Technical Service BULLETIN

Title: 2UZ-FE ACCESSORY DRIVE BELT NOISE

Models: '00 - '06 Tundra

ENGINE
REVISÉD
EG026-06

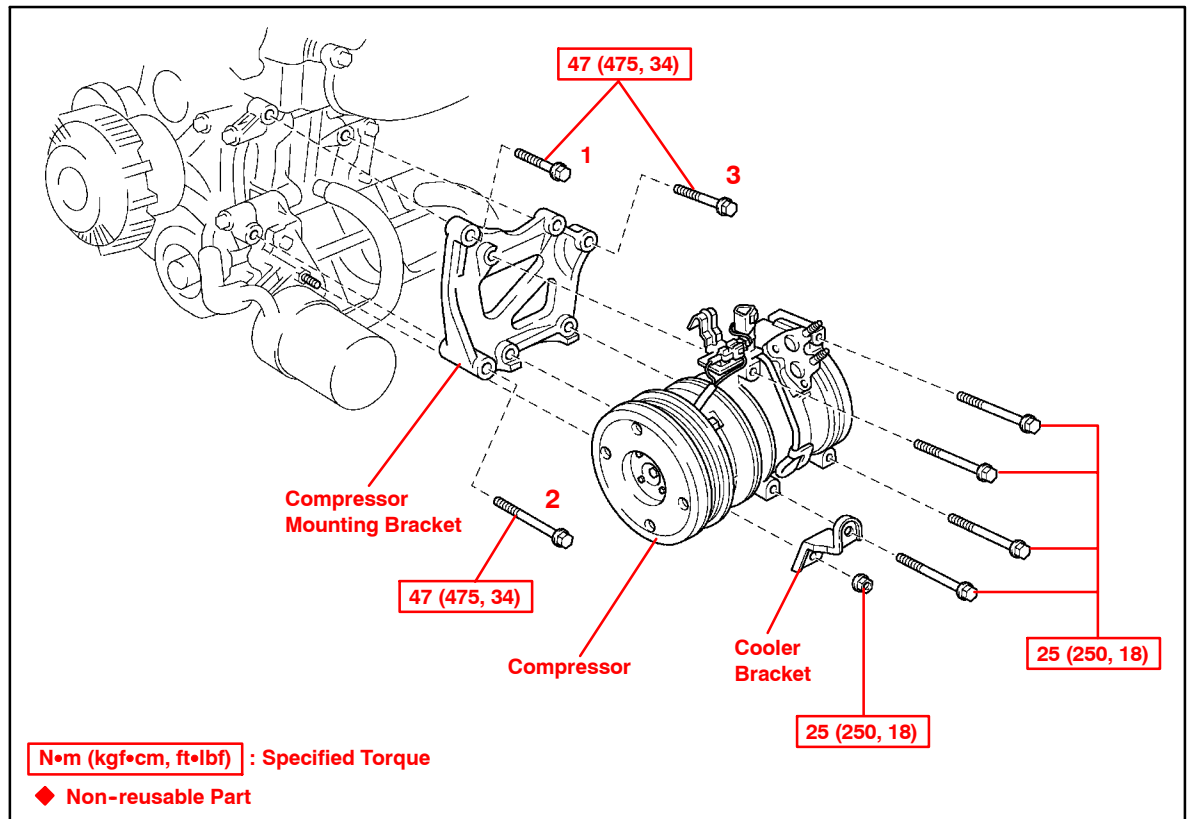
- July 9, 2007: The Introduction has been updated. Production Change Effective VINs have been updated in the Production Change Information table. In the Repair Procedure steps 12 and 13 and the illustration below step 13 have been updated, and steps 14 - 17 have been renumbered.

11. Disconnect the A/C compressor mounting bracket.
12. Install the NEW A/C compressor mounting bracket and hand tighten bolts 1 and 2 while holding the bracket forward (refer to illustration below).
13. While holding the bracket forward, tighten the A/C compressor mounting bolts in the following sequence: bolt 2, bolt 1, bolt 3.

Torque: 47 N•m (475 kgf•cm, 34 ft•lbf)
